2.5.4 Stability of Subsurface Materials and Foundations

Figure 2.5.4-4 - ESP Site-Specific Base Shear Wave Velocity Profile

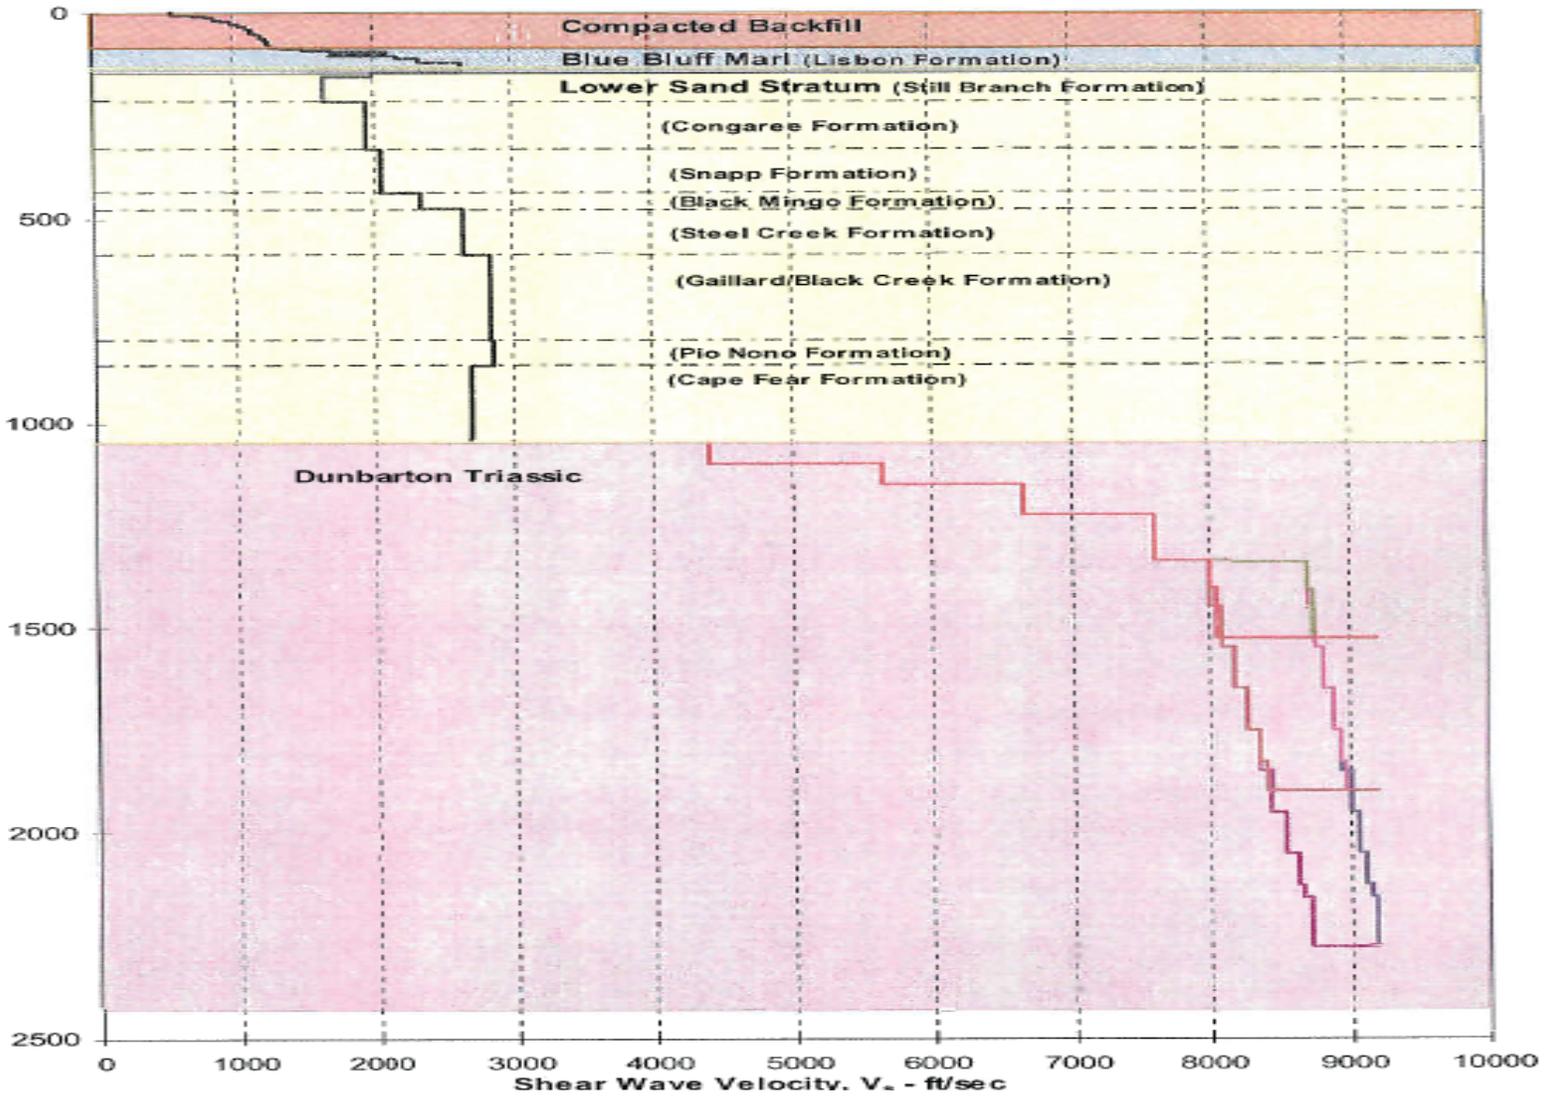
In RAI 2.5.4-3, the staff asked the applicant to explain how it developed the base case shear wave velocity profile based on only 12 borings, since most of them did not go deeper than 91.4 meters (300 ft). In its response to RAI 2.5.4-3, the applicant stated that it developed the base case shear wave velocity profile associated with the Lisbon Formation (Blue Bluff Marl), Still Branch Formation, and the upper portion of the Congaree Formation from the results of the three suspension P-S velocity logging tests performed at the ESP site. One of the suspension P-S velocity logging tests extended into bedrock below the Lower Sand Stratum, and the applicant used those results to derive the base case shear wave velocity profile below the top of the Congaree Formation. The applicant explained that its randomization model, which captures the uncertainty in the base case shear wave velocity profile for the in situ soils, used logarithmic standard deviation of shear wave velocity as a function of depth, which is set to values obtained from soil randomization performed at SRS. After reviewing the applicant's response, the staff, however, finds that shear wave velocities vary significantly among the three profiles (ESP, VEGP, Units 1 and 2 and SRS, most of them terminate at a depth of about 85.34 to 60.96 meters (280 to 300 ft)), shear wave velocities measured from down-hole seismic tests are lower than the suspension P-S velocity measurements. Furthermore, the shear wave velocities from previous investigations were relatively lower than those obtained from the ESP investigations. Therefore, the staff concludes that the applicant did not provide sufficient shear wave velocity measurements to define the site-specific shear wave velocity profile. This is **Open Item 2.5-18**.

2. The applicant provided a site-specific shear wave velocity profile in a situation that the shear wave velocity measured from the down-hole tests were lower than the ones obtained from the suspension P-S velocity measurements; the shear wave velocities from previous investigations associated with VEGP Units 1 and 2 were also lower. Additionally, the applicant did not perform soil dynamic testing on the samples from the ESP site to provide soil modulus reduction and damping curves to feed into the site response study and the site-specific shear wave velocity profile. The shear wave velocity profile and the shear modulus reduction curves, as well as the damping curves, are critical input for the site-specific ground motion spectrum and future SSI.

**Figure 2.5.4-5 - Shear Modulus Reduction Curve For SHAKE2000 Analysis—EPRI Curve
(Reproduced from SSAR Figure 2.5.4-9)**

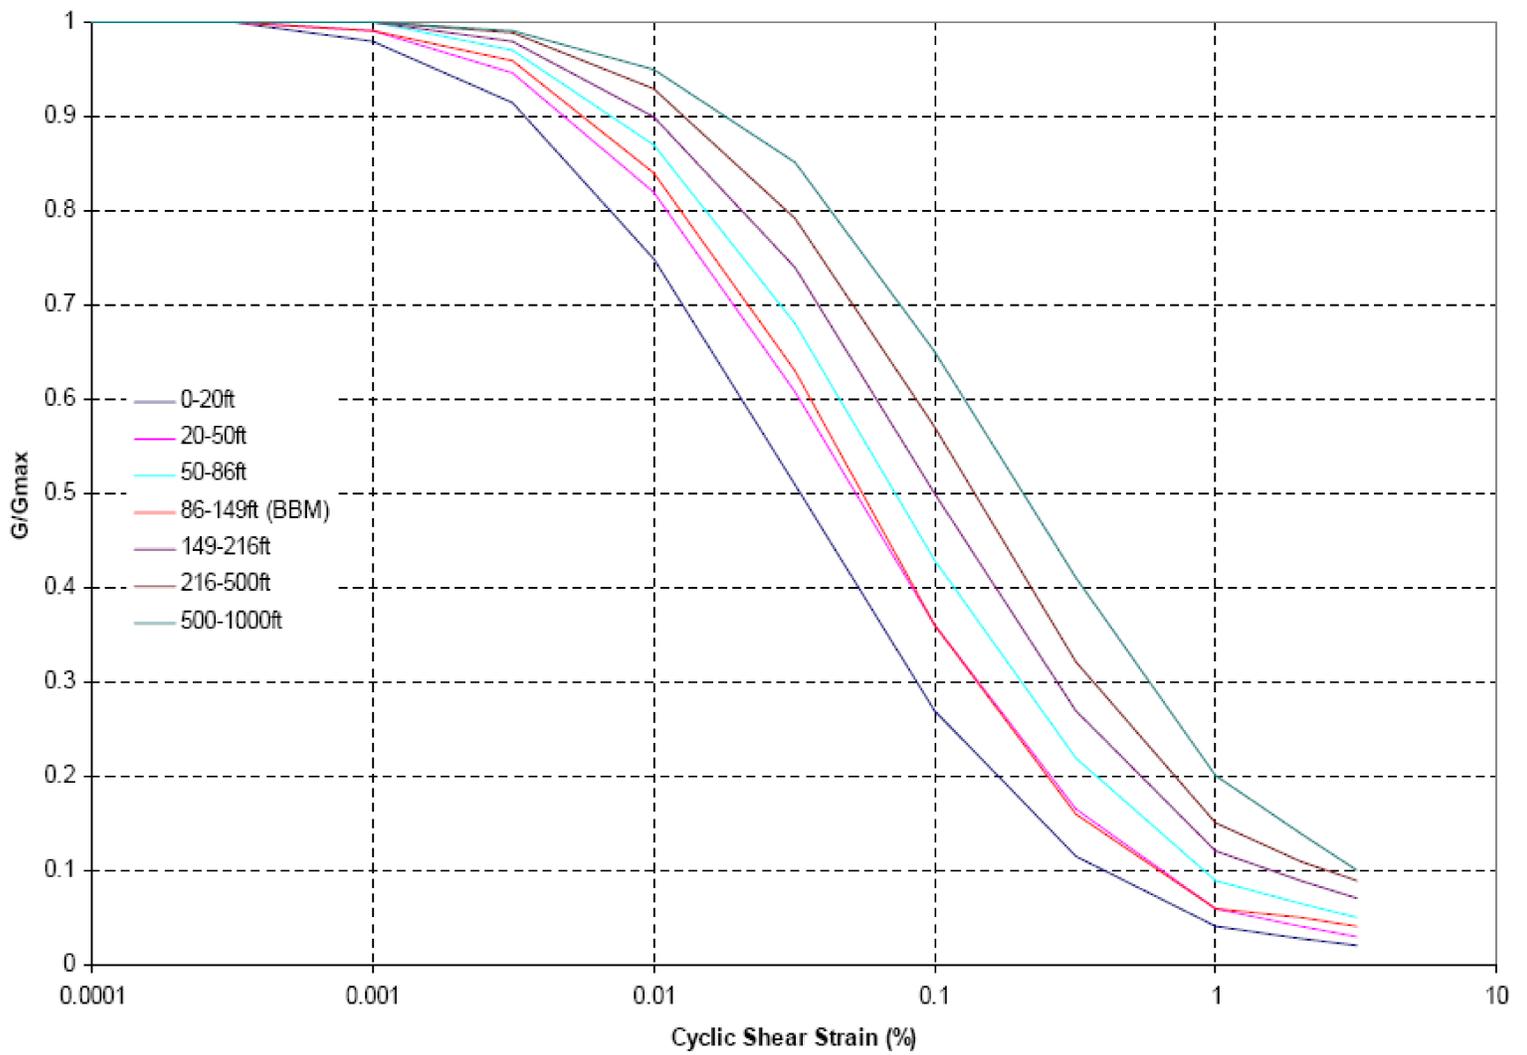
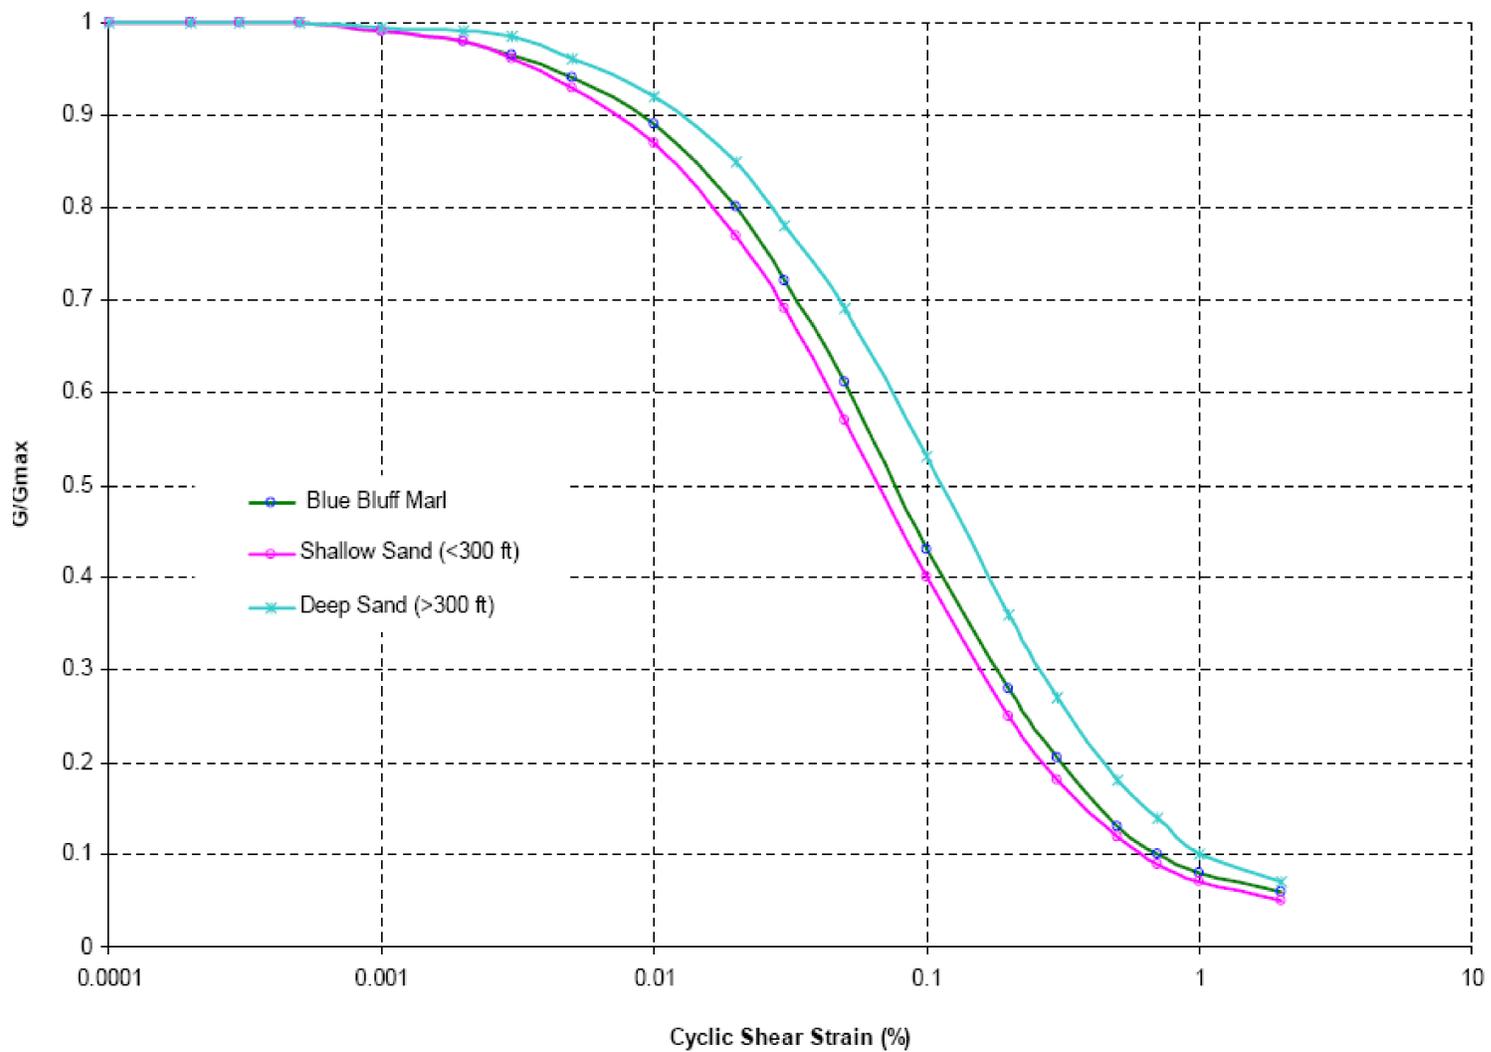
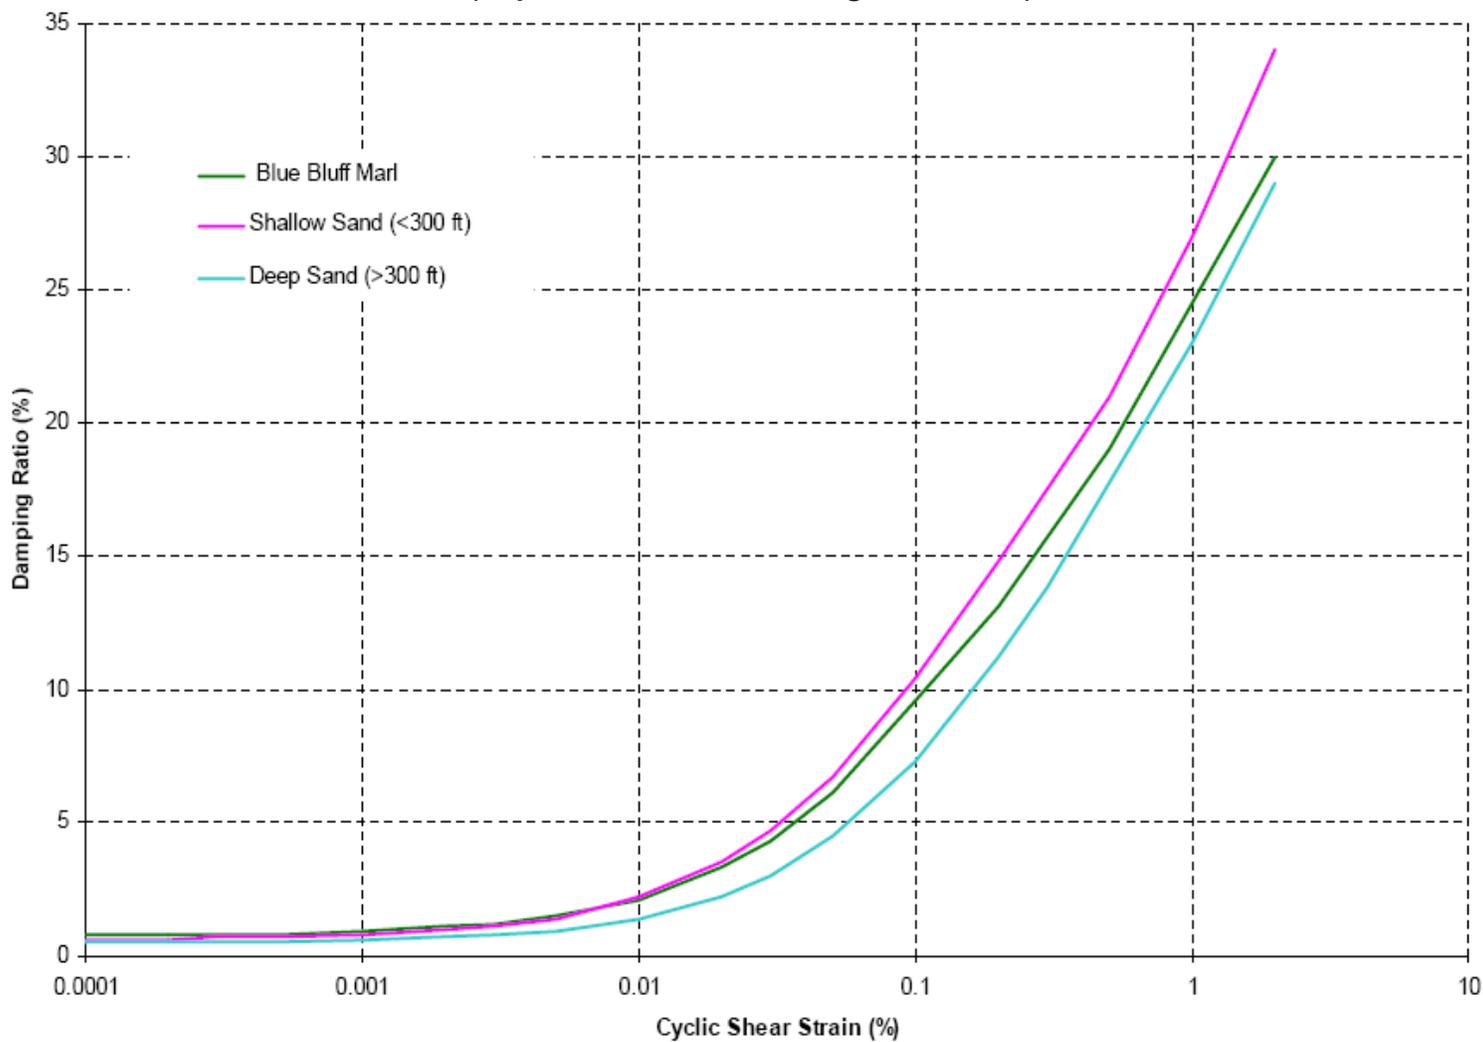
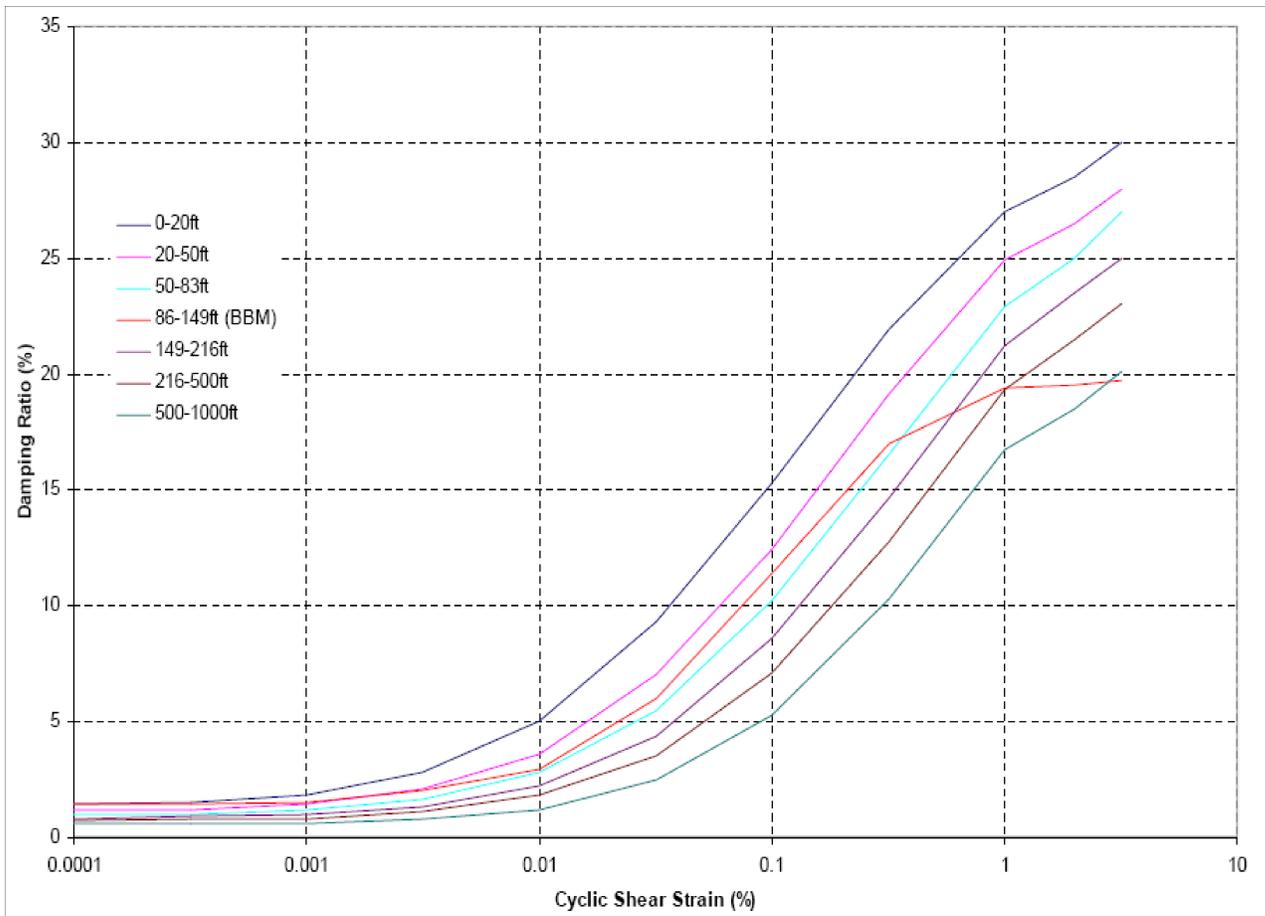
The applicant derived ESP soil shear modulus degradation and damping curves from the curves developed by EPRI (1993). In RAI 2.5.4-5, the staff asked the applicant to justify its application of the EPRI curves to fine-grained soils. In its response, the applicant stated that EPRI (1993) developed degradation curves for soils from gravels to high plasticity clays, and thus it was appropriate to apply the curves to fine-grained soils. EPRI (1993) presented fine-grained soils in Figures 7.A-16 (shear modulus reduction curves) and 7.A-17 (damping ratio curves) in terms of soil plasticity and required the use of the PI. The applicant referred the staff to its response to RAI 2.5.4-17 for more details on how it derived the degradation curves from the EPRI (1993) curves. The applicant further indicated that it would verify the soil degradation relationships for fine-grained soil (and coarse-grained soils) used in the SSAR by laboratory testing during COL subsurface investigation.

After reviewing the applicant's response and its references, the staff finds that Section 7A.6 of the EPRI (1993) report recommends the modulus degradation and hysteretic damping strain-dependent curves for generic CEUS sites. According to the report, these curves are intended for gravelly sands to low plasticity silty or sandy clays and should not be applied to either very gravelly or very clayey deposits. The curves presented in the report for silts and clays of high plasticity are significantly different from those for sandy soils. In its response to RAI 2.5.4-10, however, the applicant indicated that the Blue Bluff Marl "is described as hard, slightly sandy, cemented calcareous clay, and with less than 50% fine material," which is different from the type of materials for which the curves are intended. Therefore, the applicant did not adequately explain why it is appropriate to apply those relationships to the silts and clay soils at the ESP

site. The report further states that, while the generic curves are appropriate for preliminary site studies, one should use site-specific data for final evaluations. In conclusion, the staff concurs with the applicant that it needs to verify the soil modulus degradation and damping curves. However, this verification should not wait until the COL stage. Without site-specific soil modulus degradation and damping curves, the determination of site-specific GMRS (SSE) is inadequate. To provide site-specific soil degradation and damping ratio curves for the site-specific soil amplification calculation discussed in SER Section 2.5.2 is **Open Item 2.5-19**.

Because the applicant stated in the SSAR that it used values of shear modulus and damping ratio provided by Silva (2006) to extend the EPRI curves beyond the 1- to 3.3 percent strain level, in RAI 2.5.4-13, the staff asked the applicant to justify how it extended the values beyond the 1 percent strain level and to provide a complete description and supporting data. In its response, the applicant stated that, even though it extended the EPRI curves beyond the 1 percent strain level, the maximum strains calculated during the site amplification analyses remained below 1 percent. But, the applicant then stated that it would revise SSAR Sections 2.5.2.5.1.5, 2.5.4.7.2.1, and 2.5.4.7.2.2, along with associated tables and figures, to show the degradation curves only at a 1- percent or less cyclic shear strain. Due to the applicant's commitment to revise the curves back to a 1 percent strain level without extrapolation, the staff concludes that this RAI is not resolved until the revised SSAR sections are submitted for review. This is **Open Item 2.5-20**.

1. Although the EPRI (1993) curves were up to the 1 percent strain level, the applicant did not provide information on the strain levels associated with the 10^{-4} , 10^{-5} , and 10^{-6} uniform hazard response spectra (UHRS) at the bedrock in the site response analyses and did not indicate whether the laboratory data developed during the SRS testing program carried to those levels of strain.

2. The adequacy of the equivalent-linear approximations for site response deteriorates as strain levels exceed about 0.5 percent effective shear strain. The applicant did not justify the applicability of the equivalent-linear method used in the SHAKE2000 model analysis if the strain levels were to exceed 1 percent.

3. In its response to RAI 2.5.4-13, the applicant indicated that it would revise the 3.3 percent strain level extrapolation back to 1 percent for the EPRI (1993) modulus reduction and damping curves, however, its response to this RAI indicated otherwise.

6. Other RAI responses indicated that the applicant used both SRS and EPRI (1993) models in the site response analyses and weighted them equally. Considering that site-specific data are almost always desired over generic models, the applicant needs to evaluate the strain level difference in the surface UHRS at different exceedance levels that result from application of these different models and to justify if the equal-weighting approach is appropriate.
